# Lake Oroville Spillways Emergency Recovery

## Board of Consultants Memorandum No. 8 – June 23, 2017

## Board of Consultants Memorandum

SUBJECT: Memorandum No. 8

**Figure 8. Soil material left in place in the existing FCO chute spillway foundation interface. Location is near Station 25+30. Tool at right is 1.5 inches wide.**

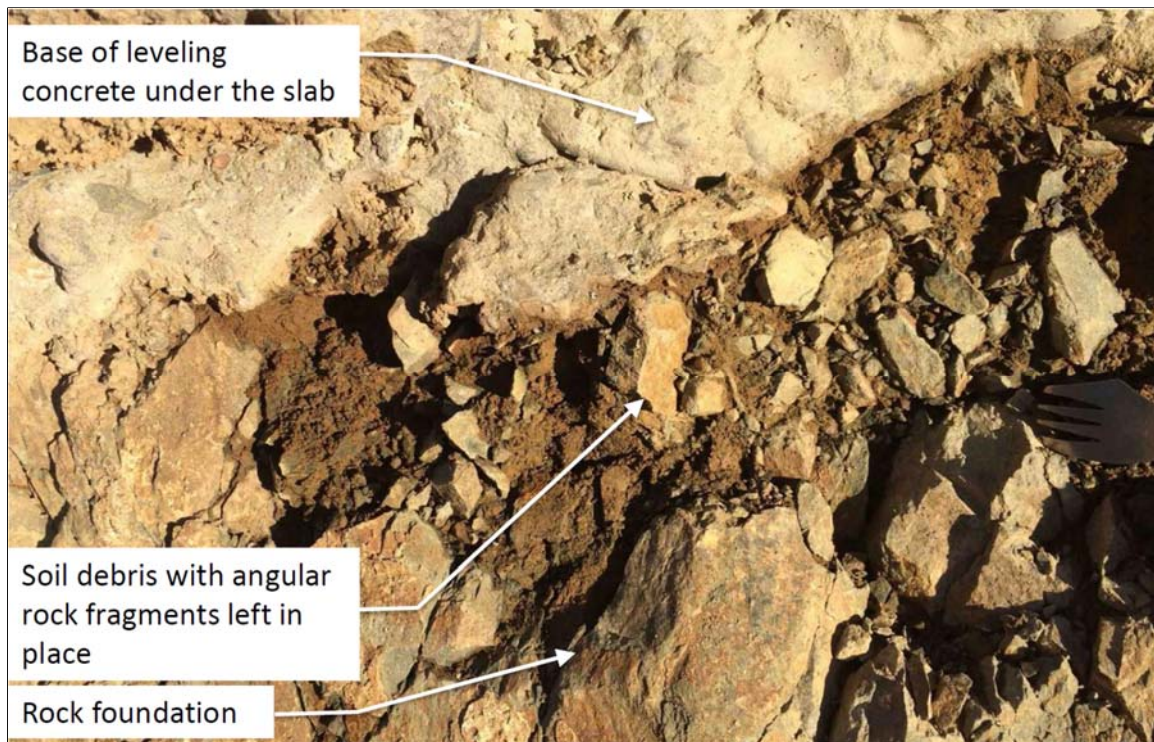
2. **Update on investigation of existing FCO spillway chute foundation condition.** The BOC was provided an update to findings on the investigation of the interface between the concrete and rock material. Four concrete cutouts were excavated and exposures described. Subsequently, and as part of the concrete removal, the Contractor created a 200-foot-long centerline exposure of the interface from Stations 25+00 to 27+00. Where present, the soil material that did exist appeared to be semi-consolidated fines and angular rock debris that was not removed as part of the initial (1960's era) foundation surface cleanup. The interpretation of the investigators was that the localized occurrence of the soil and its angular nature did not appear to be fill that was purposefully placed as bearing material. A photo of this material is shown as Figure 8.
